Access Compliance Report

Public Rights-of-Way

Intersection ID: 29933	Main Street: CAROLINA LILY LN	Cross Street: APPLEDALE DR	Location: SW
ADA ID: D0DB0197A0F6	Ramp Type: BlendTrans1	Initial Pass/Fail: Fail	Overall Compliance: No
Severity Score: 25			
Codes/Mitigation Info/Possible Solution		Field Measurements/Component Compliance

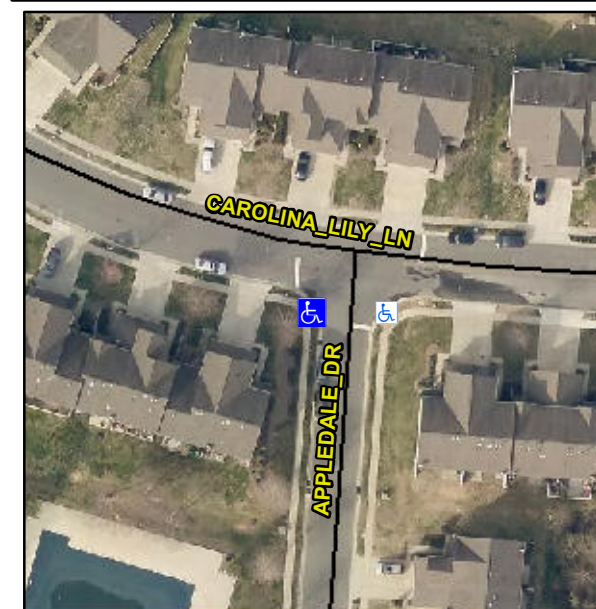
Not Found, R304.5.3

Compliance	Description	Data	Compliance	Description	Data
N/A	Ramp Length (in)	36.0	Yes	BlendTrans Slope (%)	0.2
Yes	Ramp Width (in)	193.0	No	BlendTrans XSlope (%)	8.1
N/A	Flare Type LT	N/A	N/A	Flare Type RT	N/A
N/A	Flare Slope LT (%)	N/A	N/A	Flare Slope RT (%)	N/A
N/A	Flare Traversable LT?	N/A	N/A	Flare Traversable RT?	N/A
N/A	Landing Length (in)	N/A	N/A	DWS Provided?	N/A
N/A	Landing Width (in)	N/A	N/A	DWS Contrast?	N/A
N/A	Landing Slope (%)	N/A	N/A	DWS Length (in)	N/A
N/A	Landing X Slope (%)	N/A	N/A	DWS Full Width?	N/A
N/A	Landing Curb? (Y/N)	N/A	N/A	DWS Offset (in)	N/A
N/A	Shared Landing?	N/A			
N/A	Gutter Ponding?	N/A	N/A	Gutter Slope (%)	N/A
N/A	Gutter Lip Ht (in)	N/A	N/A	Gutter X Slope (%)	N/A
N/A	Painted X Walk1?	No	N/A	Painted X Walk2?	No
	X Walk 1 Direction	To E		X Walk 2 Direction	To N
	X Walk 1 Width (in)	N/A		X Walk 2 Width (in)	N/A
	X Walk 1 Slope (%)	4.2		X Walk 2 Slope (%)	4.7
	X Walk 1 X Slope (%)	5.9		X Walk 2 X Slope (%)	4.2

Remove & Replace Curb Ramp With Two New Directional Ramps or Equivalent.
